Townsend - South

Environmental Assessment and “Nationwide” Section 4(f) Evaluations

Project NH-F 8-4(16)78; Control No. 1420
Broadwater County, Montana

REVISED
ENVIRONMENTAL ASSESSMENT
and
"NATIONWIDE" SECTION 4(f) EVALUATIONS

Townsend - South
REVISED Figure 3
 Lane Configurations
 Preferred Alternative

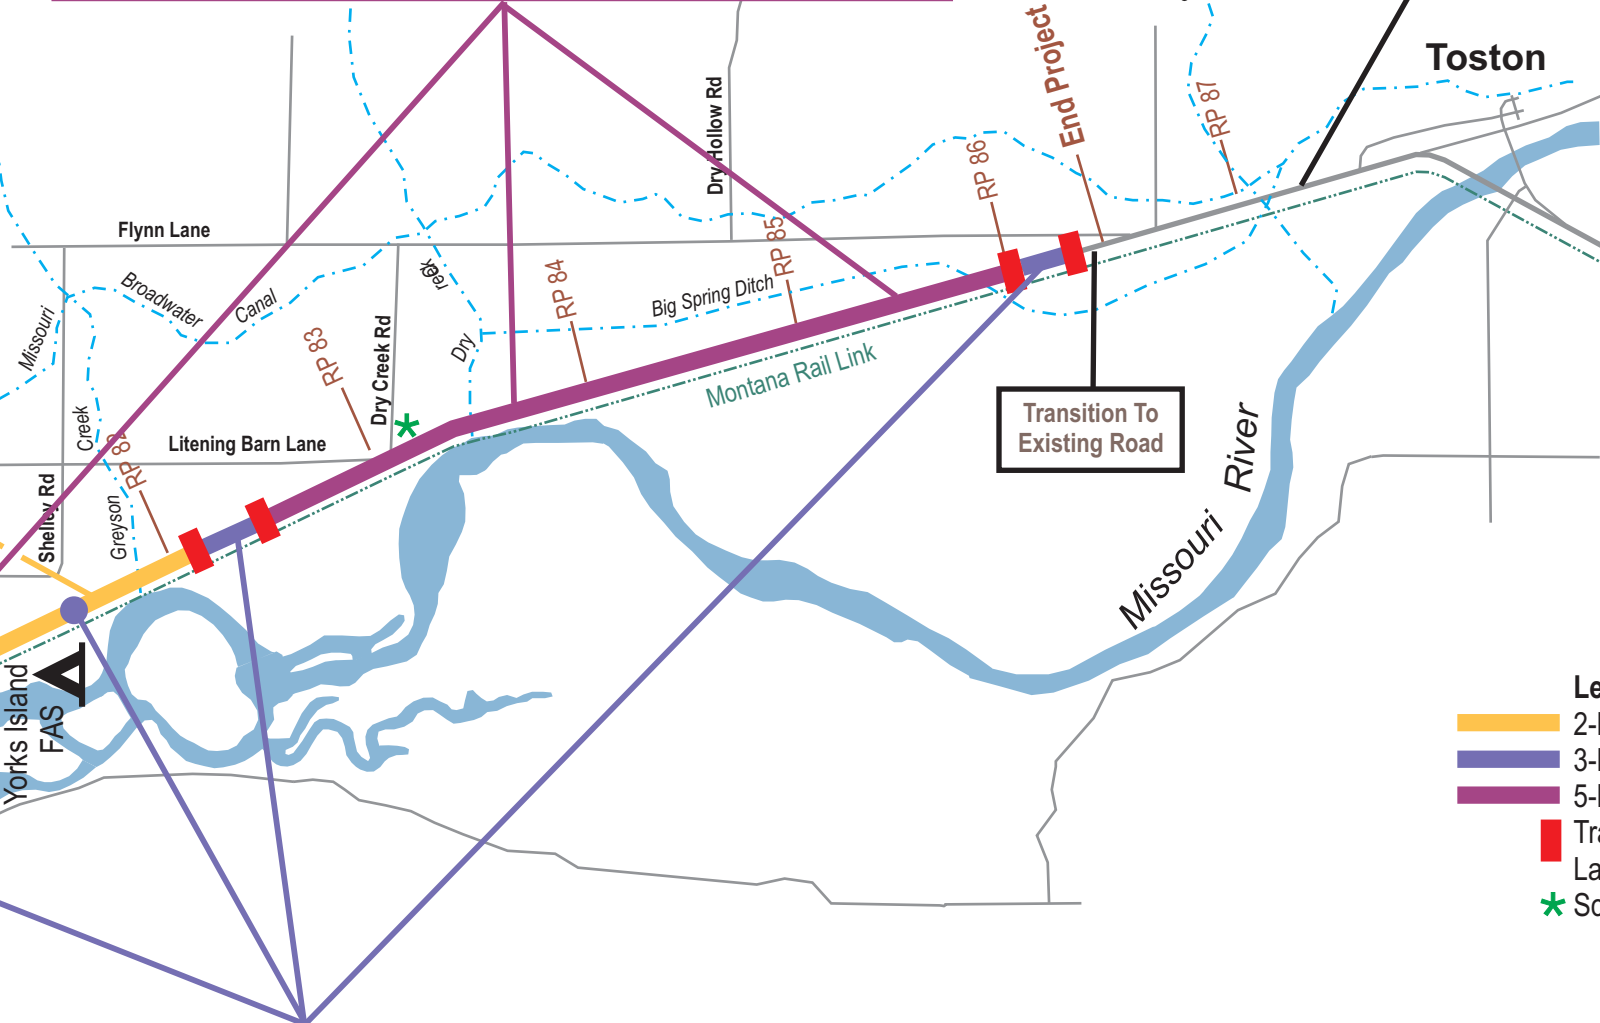
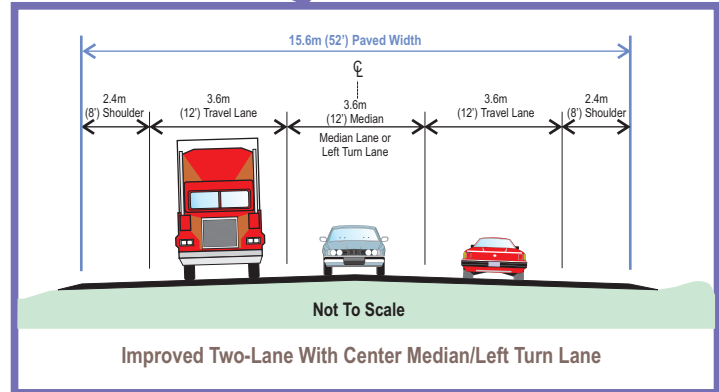
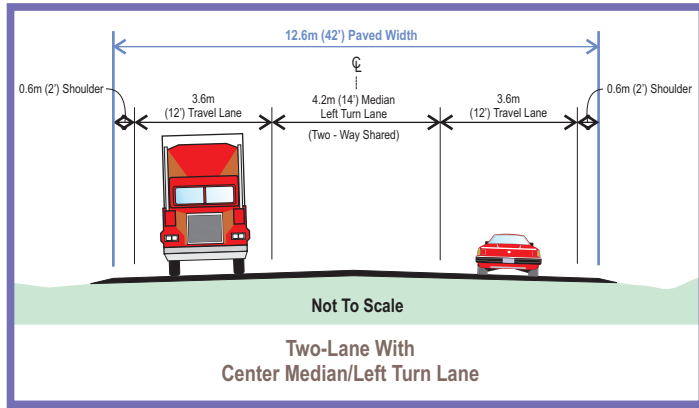
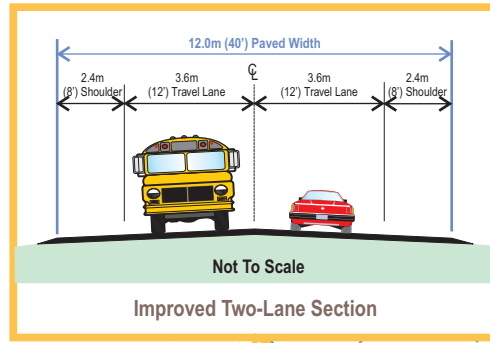
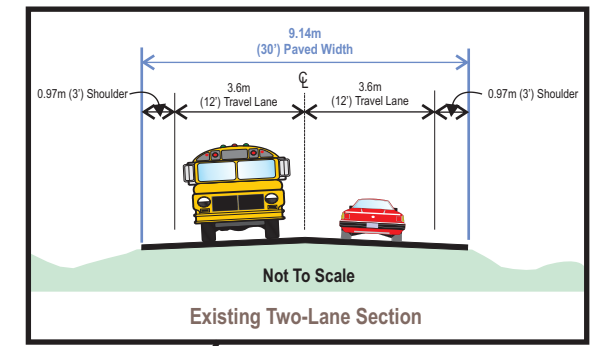
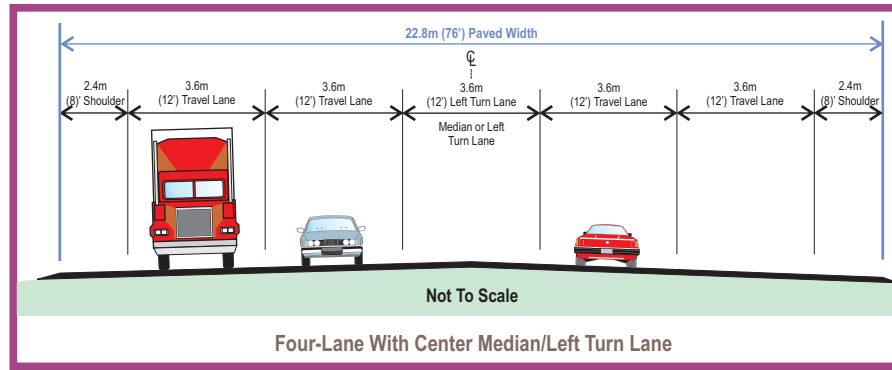
This document also allows MDT to clarify design details for the passing areas included with the Preferred Alternative. The graphic showing proposed lane configurations (**FIGURE 3** in the EA distributed in November 2005) inadvertently showed passing areas as undivided four-lane sections. MDT proposes that passing areas be 22.8 meters (76-feet) wide and consist of four driving lanes and a center median/left turn lane. Although the EA disclosed that the passing areas may include sections with five-lanes, the document did not clearly represent that passing areas would be developed with five-lane typical cross-sections.

FIGURE 3 in the EA showed three areas in the project corridor where improved two-lane sections would be provided. The Preferred Alternative includes only two areas with an improved two-lane typical section and has other adjoining areas with three-lane typical sections. Additionally, the figure did not provide any indication of where transitions occur between various lane configurations. The figure suggested abrupt changes would exist between areas with different lane configurations. In reality, gradual transitions would be constructed in areas where the roadway width and lane configurations change.

The discrepancies between the proposed lane configurations shown on **FIGURE 3** in the EA and MDT's design proposal were disclosed at the December 15, 2005 public hearing. The display boards used by MDT during the engineering presentation at the hearing accurately showed the proposed lane configurations for this project. These aerial photo displays were frequently referenced during the presentation, the oral comment period, and during informal discussions with the public.

Circulating a Revised EA allows MDT to accurately show the lane configurations associated with the Preferred Alternative and eliminate any confusion that may have been created by the original lane configuration graphic.

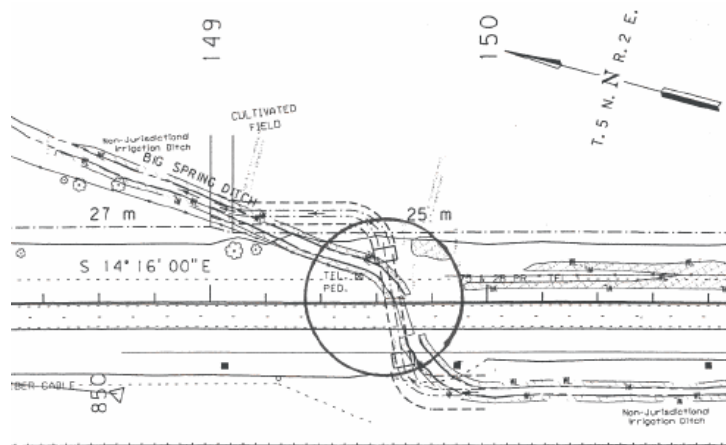
COMMENT 2B: *Another thing, on one of the slides it showed three bridges, so I don't know if the Spring Ditch Bridge doesn't count. On Spring Ditch, when the current highway went in, they changed the alignment of the ditch and that bridge needs to go back in on the skew because we've had a run-in with the local maintenance crew when we cleaned the ditch because the ditch is at a right angle to the highway.*

RESPONSE: We assume this comment refers to the Big Springs Ditch crossing on U.S. Highway 287 which is a concrete box culvert and not a bridge. A preliminary design drawing shown below indicates the existing concrete box culvert would be replaced with a new irrigation pipe beneath the highway and the inlet and outlet channels for the ditch would be realigned. The dashed lines shown in the figure indicate the proposed new alignment of the ditch.

The new pipe beneath the highway would not be skewed to the same degree as the existing culvert. Realigning the ditch so as much of this irrigation facility is outside the new right-of-way and away from roadway should help local maintenance efforts.
